service bulletin

M86-11

28 May 1986

SUBJECT: CONNECTING ROD PRODUCT IMPROVEMENT**COMPLIANCE:** At Next Engine Overhaul, Top Overhaul, or Anytime Cylinders are
Removed For Any Reason

FIGURE 1. CONNECTING ROD.

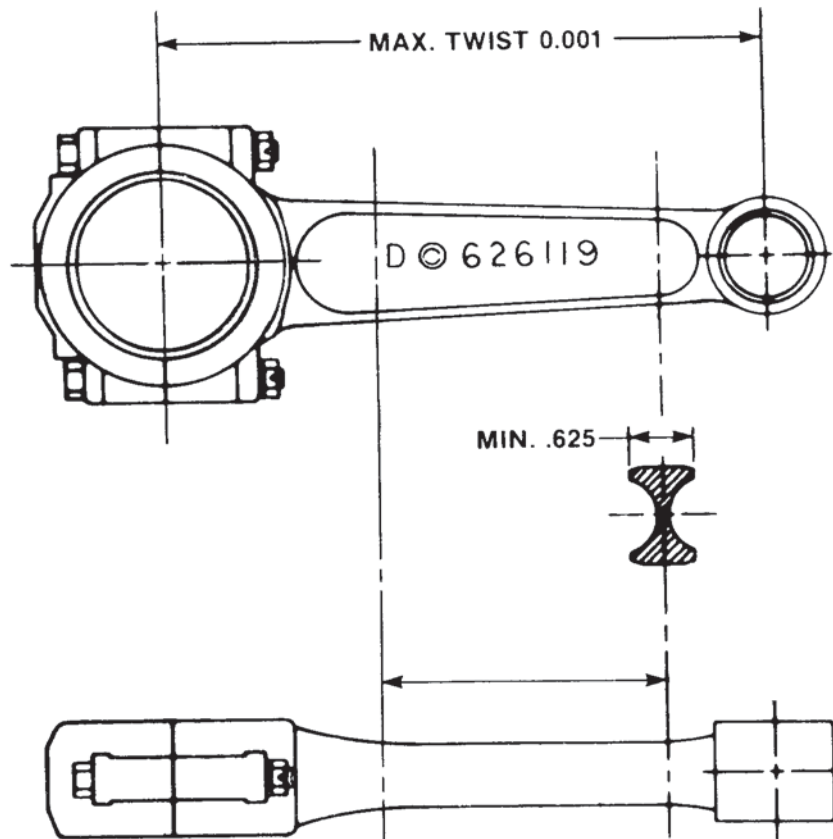
We recommend that at any time access is gained to the connecting rods during cylinder removal, the beam section dimension of the connecting rods with forging number 626119 be measured as per illustration Figure 1, and also as found in Overhaul Manual X30030A. Any connecting rod below .625 dimension should be replaced with a new product improvement connecting rod with additional margin of safety, P/N 646321 or P/N 646320, depending on the model affected. In addition, it is recommended that published operating and maintenance procedures be strictly followed to prevent the causes of excessive cylinder pressure as noted in the preceeding paragraph.

A larger number of over stressed connecting rods have been those identified with a forged © on the beam section. These rods were manufactured between June 1976 and September 1981. Particular attention should be paid to these rods.

NOTE: THIS INSPECTION PERTAINS TO THE 626119 FORGING ONLY

If connecting rod replacement is required, new connecting rod bearings of the appropriate part number and new cotter pins P/N 639292 should be installed. Component inspection and reassembly should be in accordance with Overhaul Manual Form X30030A.
